September 5, 2003

Refer to: HSA-10/B-107

In your May 23 letter to Mr. Richard Powers of my staff, you requested the Federal Highway Administration's (FHWA) acceptance of a recycled plastic block, called the Anro block, for use with strong steel-post w-beam guardrail on the National Highway System (NHS). Subsequently, you had the Anro block tested at the Midwest Roadside Safety Facility and sent us a copy of that agency's report, "Performance Analysis of the Anro Timber Products Recycled Plastic Spacer Block", dated August 25, 2003. Based on comparison bogey vehicle tests of a standard wood block and the Anro block, both mounted on W150 x 13.5 steel posts, the report concluded that there was no substantial difference in performance between the two offset blocks.

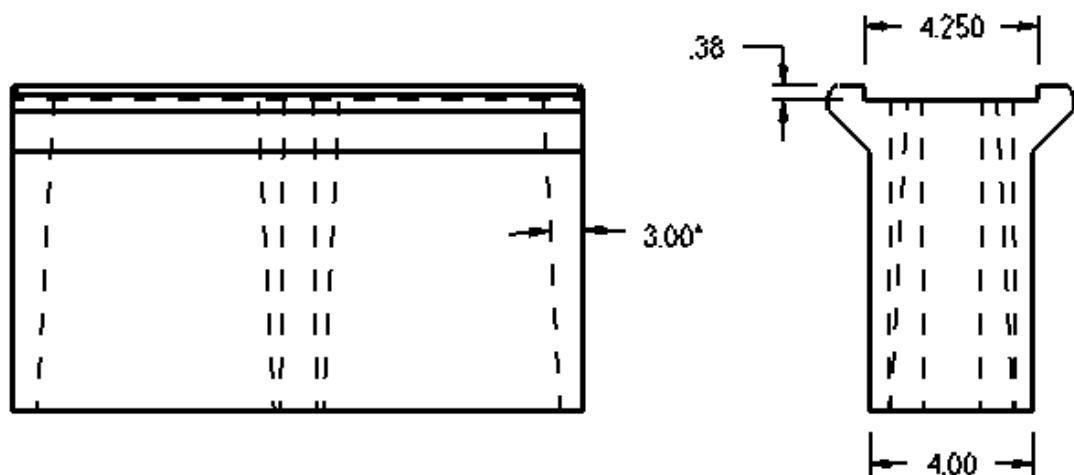
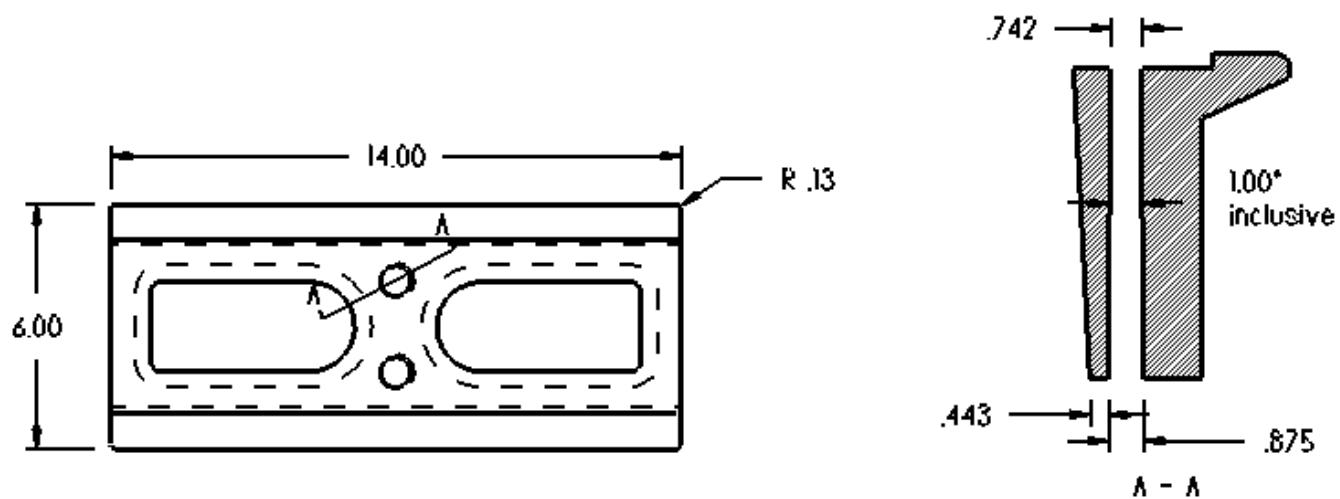
The Anro block is an injection-molded product composed of approximately 60 per cent recycled polyethylene (PE), 40 per cent polypropylene (PP), and a maximum of 2 per cent blowing agent. Each block is nominally 100-mm (4-inches) wide for 162 mm (6.38 inches), and then flares out to a post-side width of 150 mm (6 inches) over the last 41 mm (1.62 inches). A 108-mm x 10-mm (4.25-inch x 0.38-inch) routing on the backside fits over the steel post flange. The bolt hole dimensions are 0.875-inches in diameter at the rail side, tapering uniformly to a 0.742-inch diameter at the post side. These and other dimensions are shown on the enclosure.

After reviewing the test results, I consider the Anro block acceptable for use with strong post w-beam barrier on the NHS when it conforms to the dimensions, and is composed of the same materials, as noted above and as shown in the enclosure. Please note that the following provisions apply to this acceptance:
